Basis of this breakdown

1. Bulletin 3 (M-529 / M-530 / M-531, revision 4, 08/10/2026) was issued after the ductwork in the affected areas had been fabricated and installed per the Addendum 1 drawings. The change therefore includes **disconnecting and removing installed ductwork**, in addition to fabricating and installing the revised work.

Snowflake Fitout - 7 Times Square, Floors 29-31 | COP-SF-05 Bulletin 3 Revision

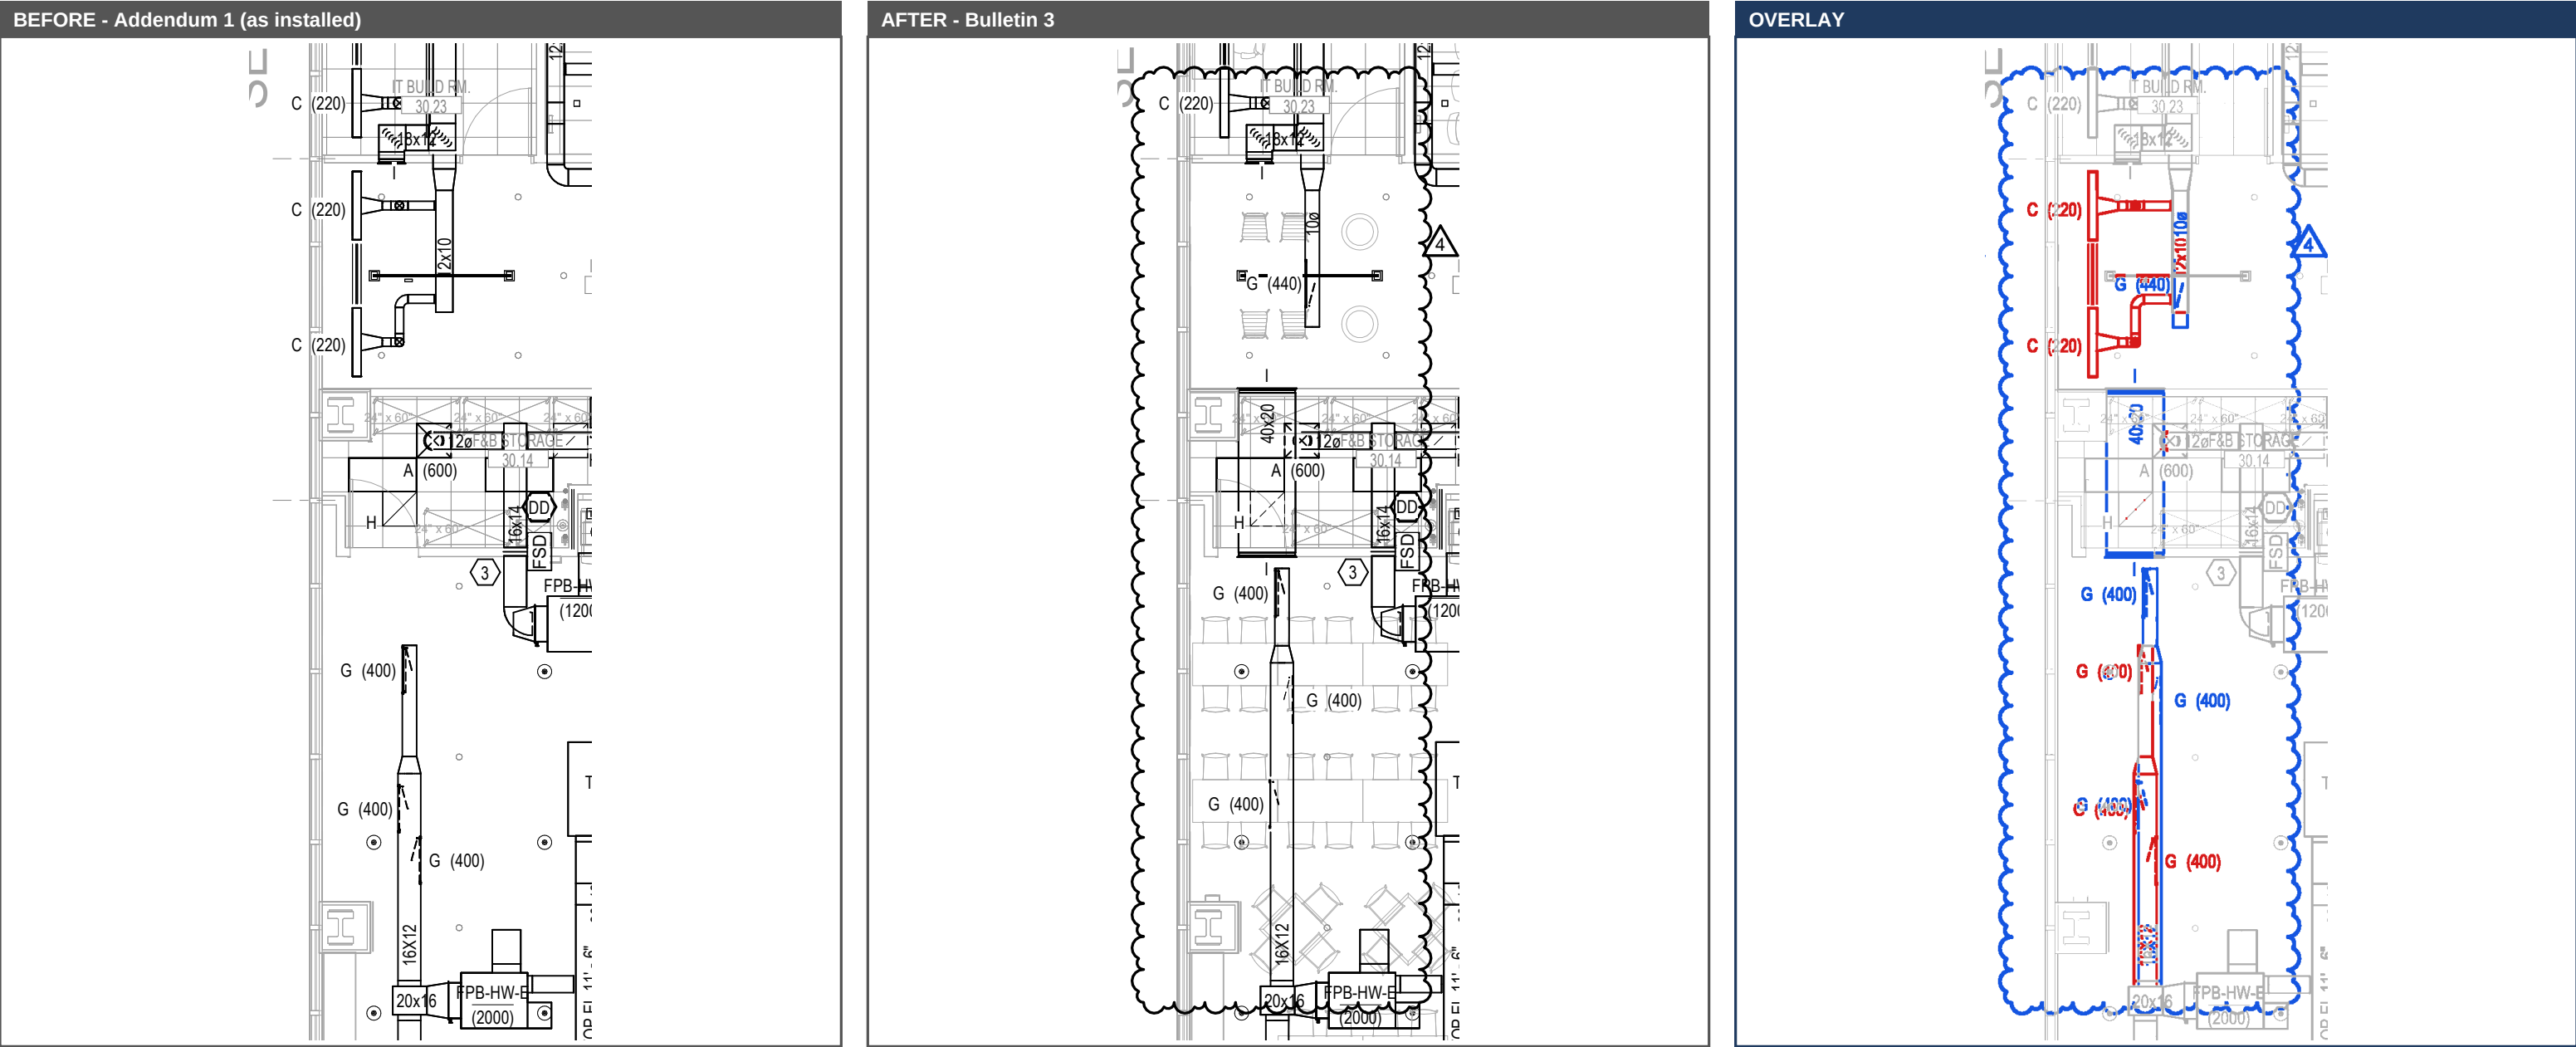
Before (Addendum 1, installed): 12x10 branch with (2) C(220) ceiling diffusers; G(400) linear diffuser run on 16x12 branch.

After (Bulletin 3): 12x10 branch and (2) C(220) deleted, replaced with 10ø branch to (1) new G(440) linear diffuser. New 40x20 transfer duct at F&B Storage 30.14. G(400) linear diffusers relocated along the 16x12 branch.

Work required: Disconnect and remove 12x10 branch and (2) C(220). Install 10ø branch, 40x20 transfer duct, rework 16x12 branch. F&I G(440) linear diffuser with plenum, relocate G(400) diffusers.

Area 30-2 - Lounge 30.02 - new transfer ducts

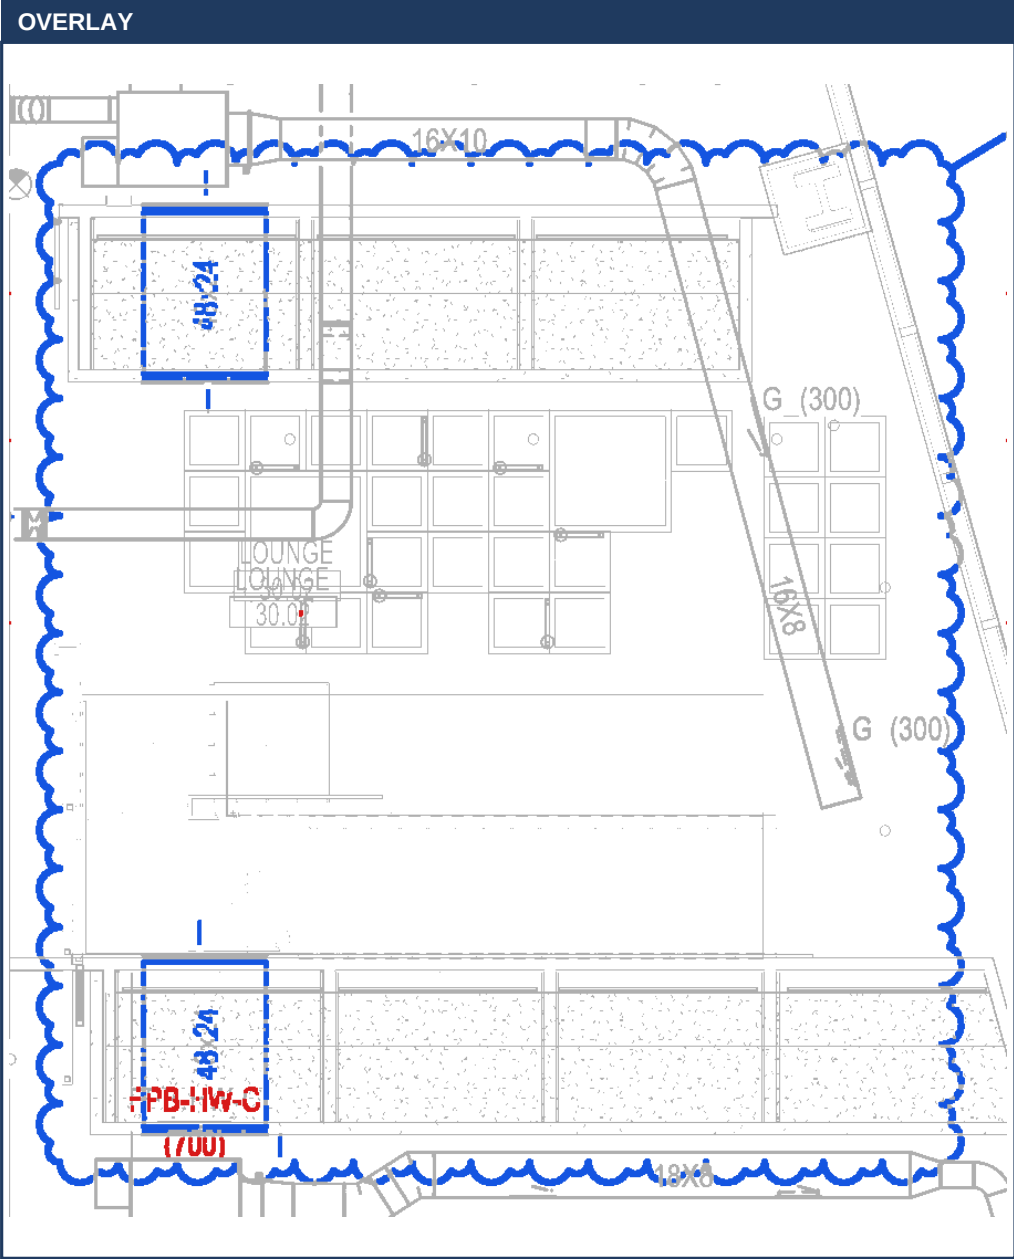
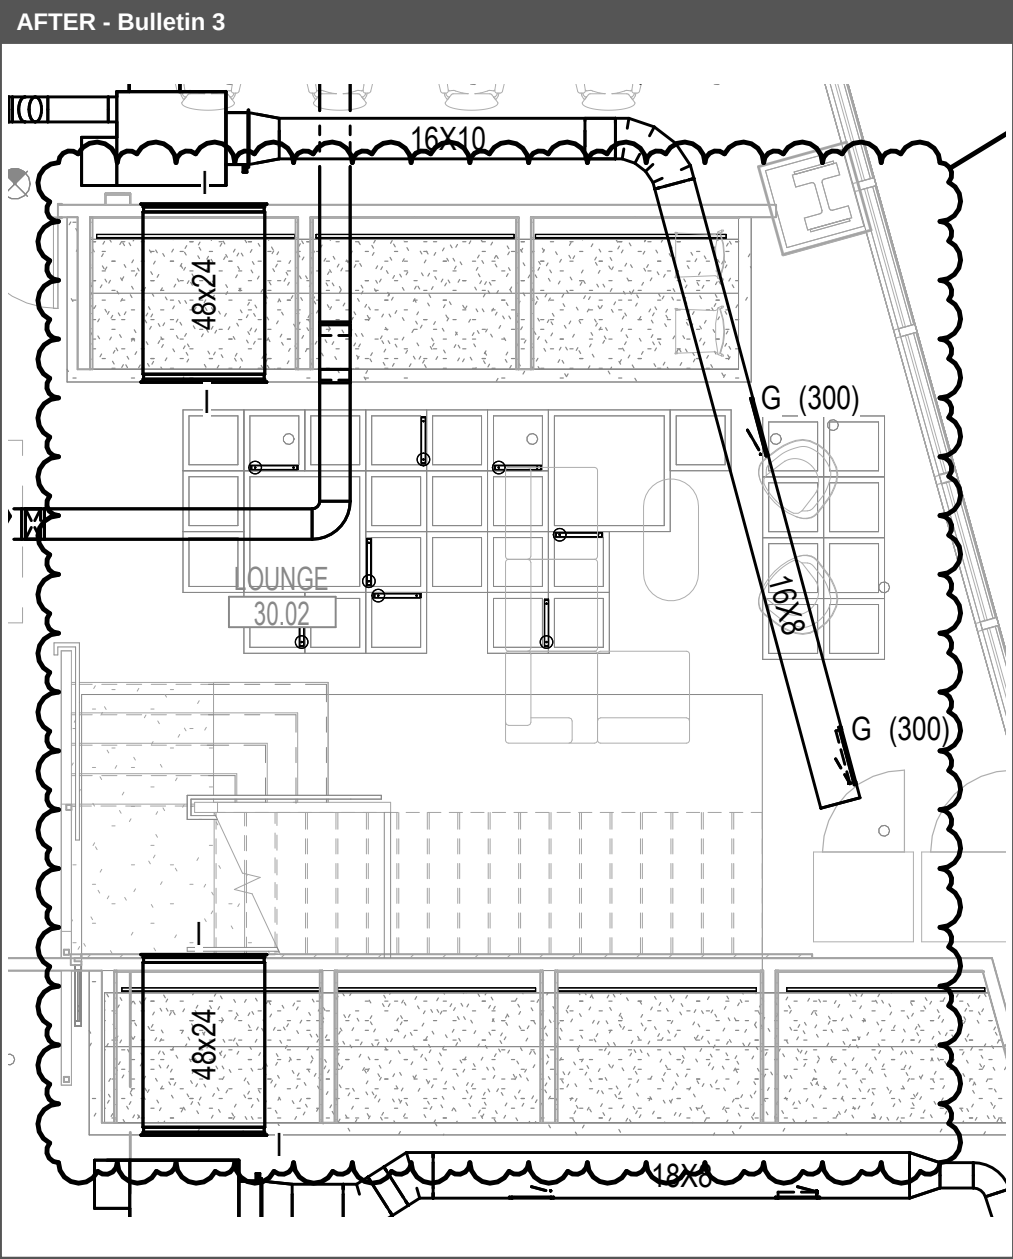
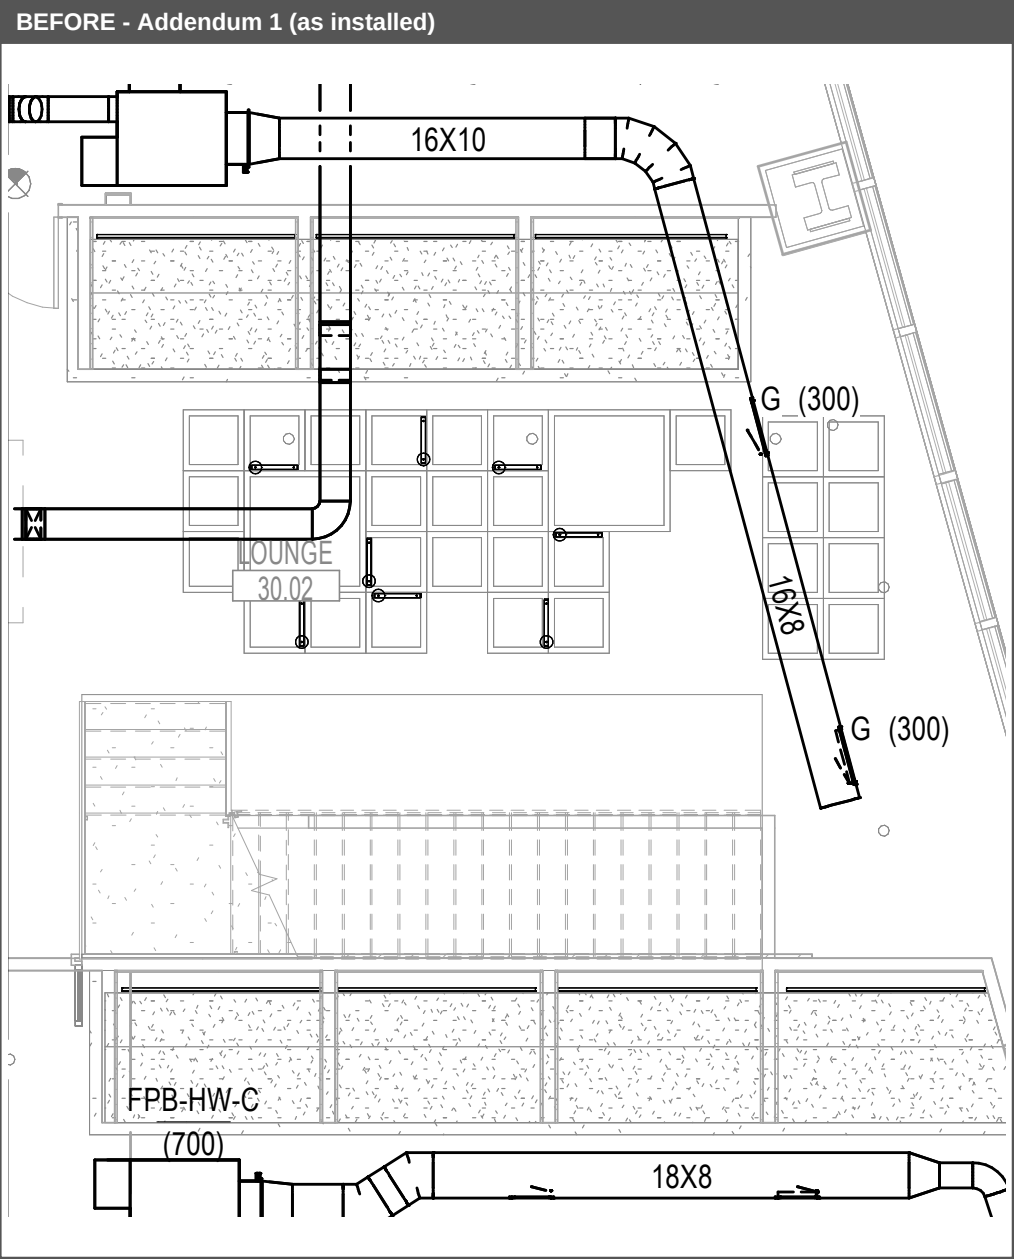
Before (Addendum 1, installed): No transfer ducts at Lounge 30.02 walls.

After (Bulletin 3): (2) new 48x24 transfer ducts.

Work required: Fabricate and install (2) 48x24 lined transfer ducts.

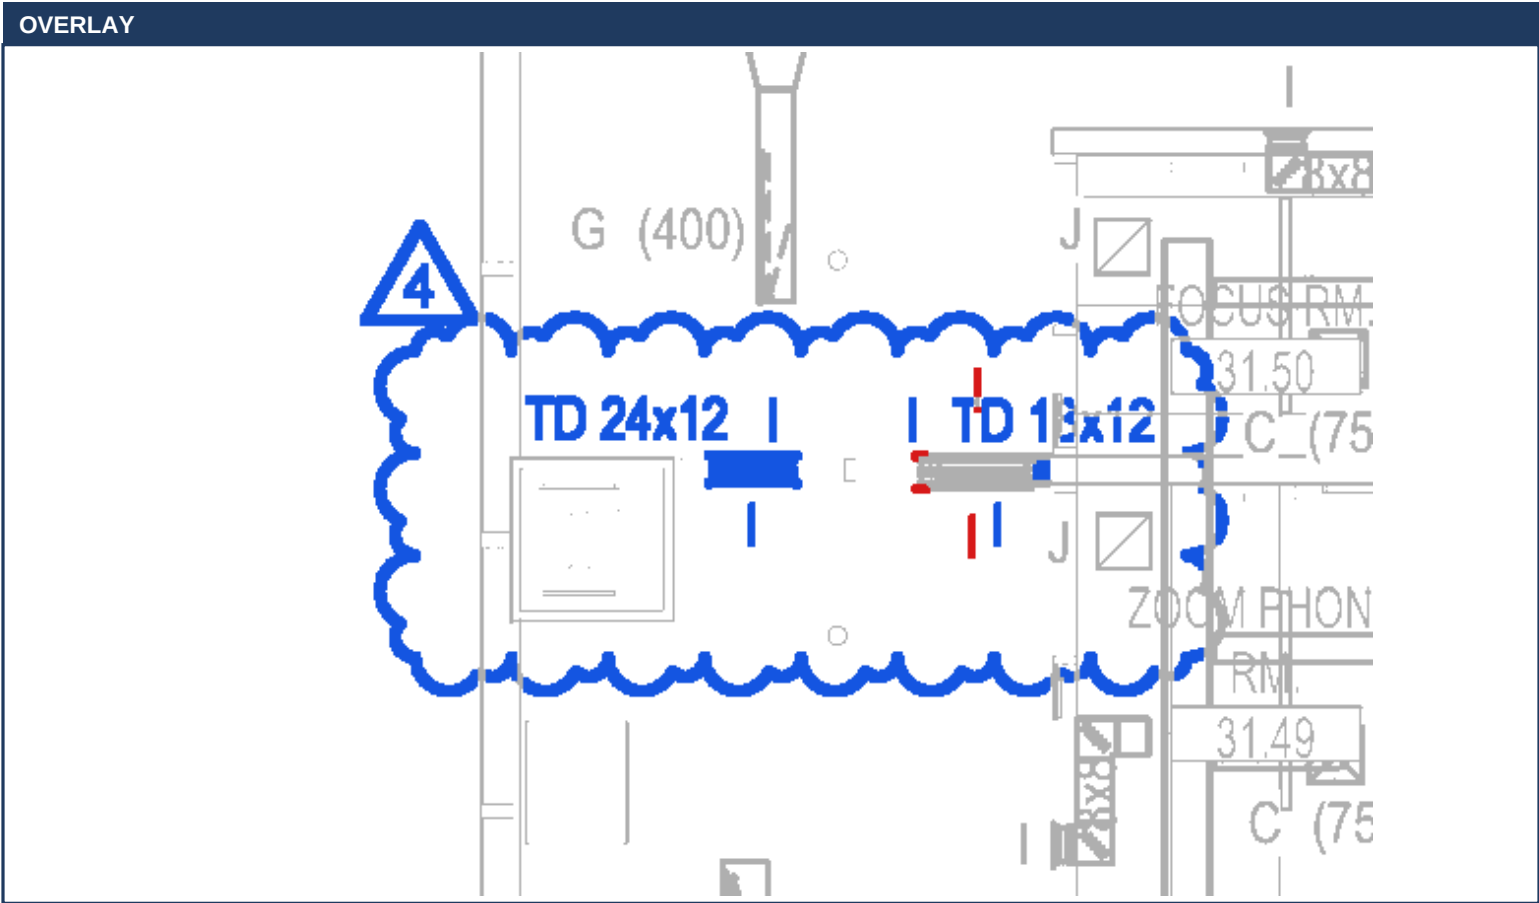
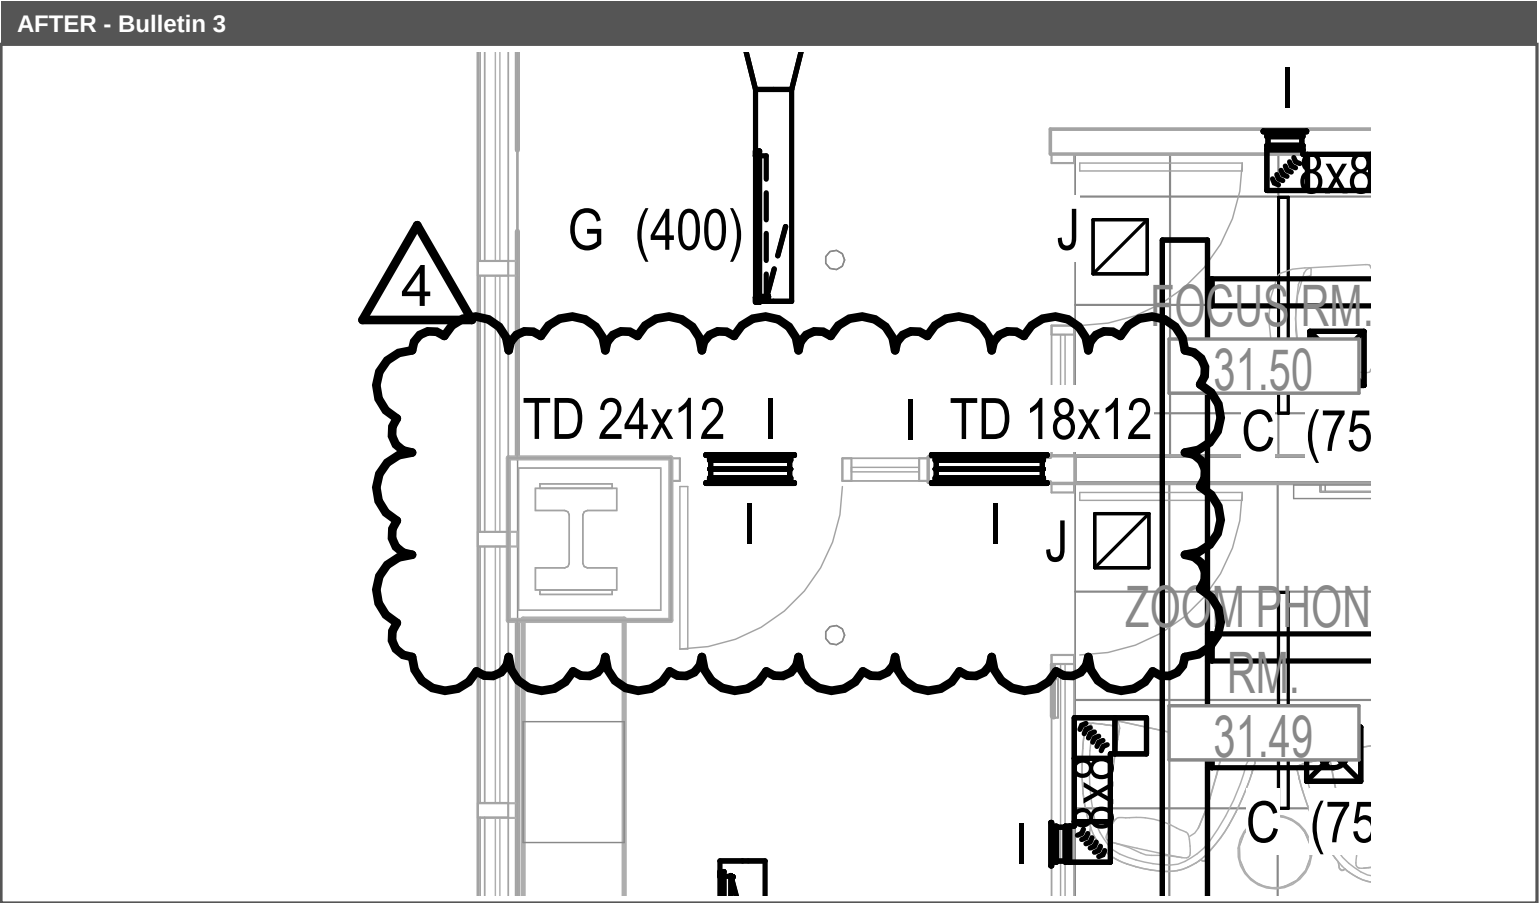
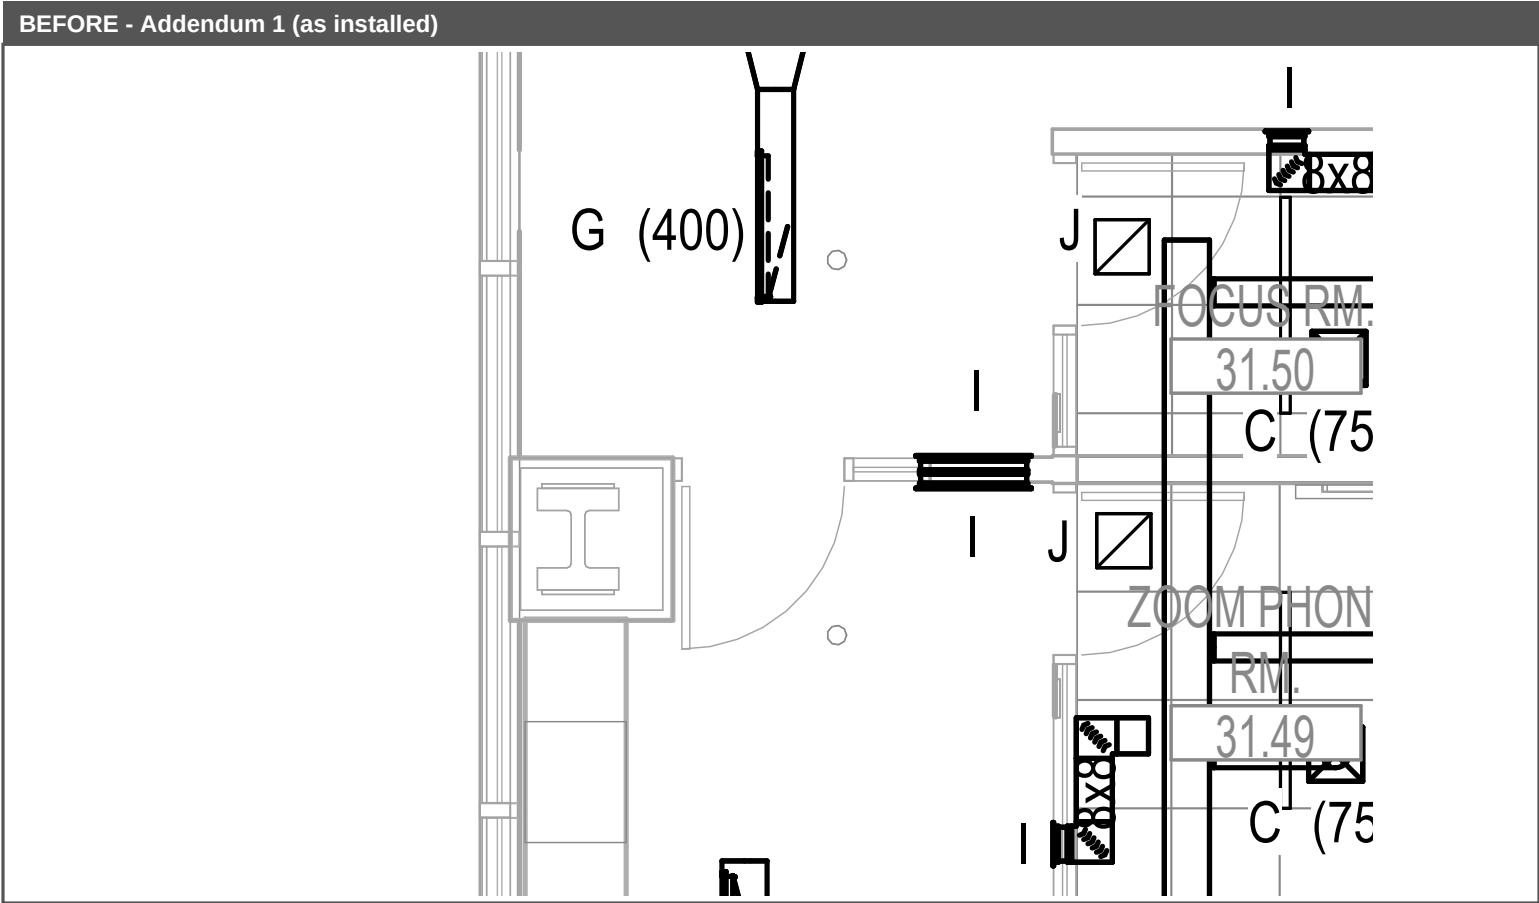
Before (Addendum 1, installed): (1) transfer duct (not sized on Addendum 1).

After (Bulletin 3): TD 24x12 and new TD 18x12.

Work required: Remove existing transfer duct; fabricate and install TD 24x12 and TD 18x12.
